PLANNING, ZONING, & BUILDING DEPARTMENT
PZ&B Staff Combination Memorandum: Architectural Commission and Town Council

SUBJECT: ARC-24-0119 (ZON-24-0072) 136 REEF RD (COMBO)

MEETING: JANUARY 29, 2025 ARCOM
FEBRUARY 12, 2025 TC

Photos depicting covered patio to be rebuilt.

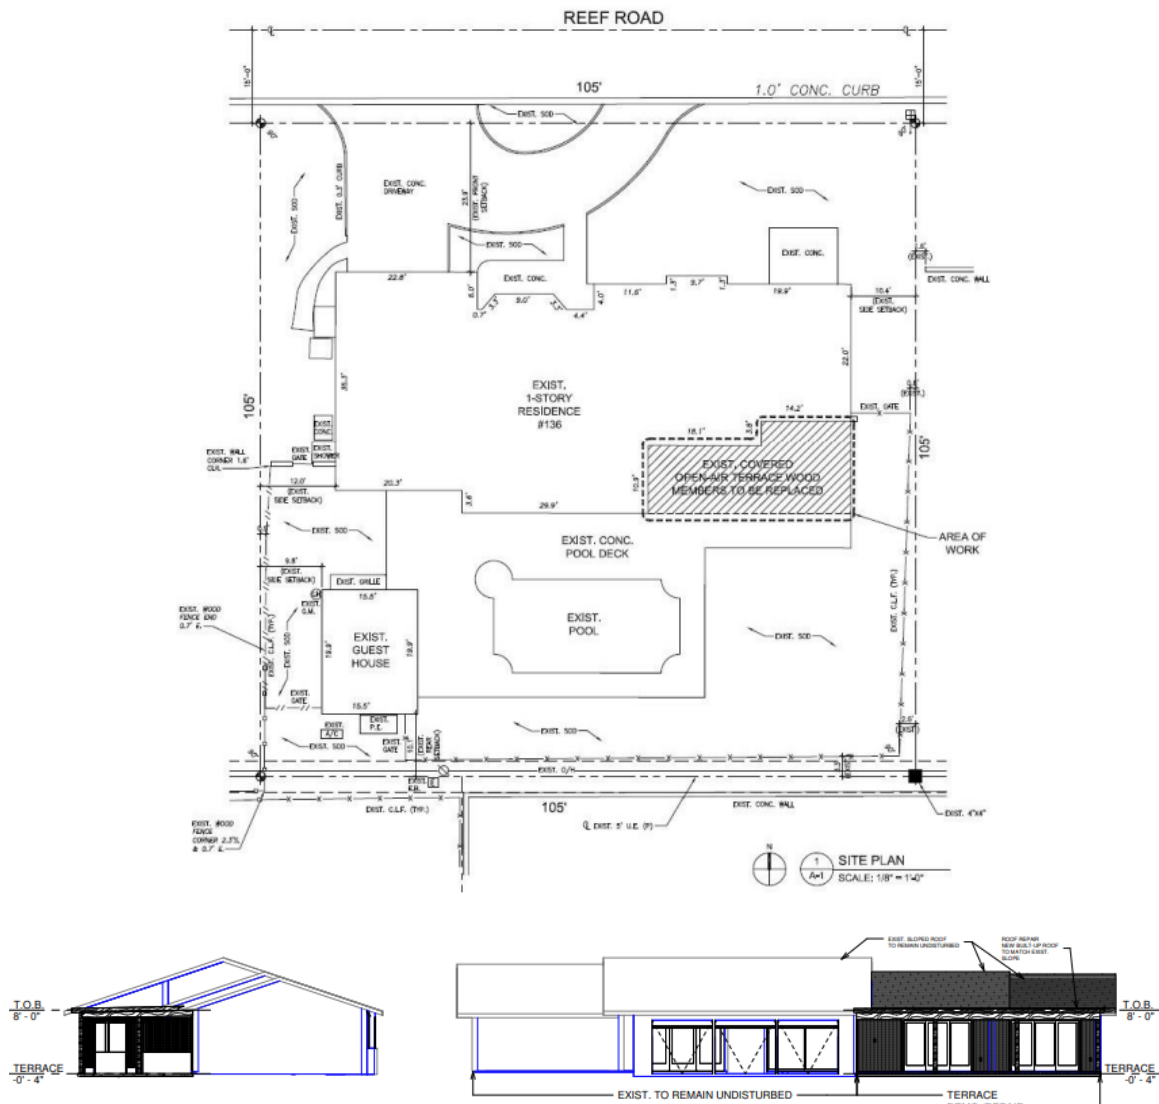
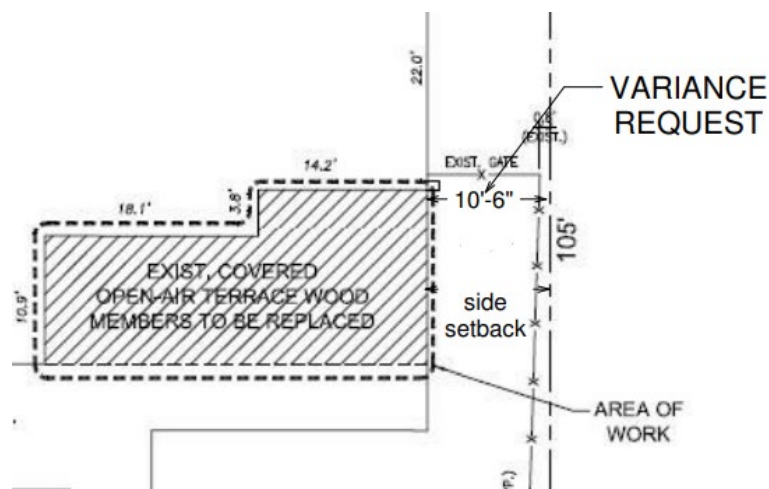
The applicant is proposing to reconstruct an existing wood frame terrace at the southeast corner of the structure facing the southeast corner of the lot. The existing one-story structure was built in 1951. This one story open air terrace has exposed wooden beams and wood lattice on the east side. The proposed terrace will replicate the existing in location and design. Due to the amount of demolition required because of wood decay this proposal requires the granting of one variance to accomplish the plan.

Due to demolition of greater than 50% of this covered terrace to reconstruct in the same footprint one variance is needed.
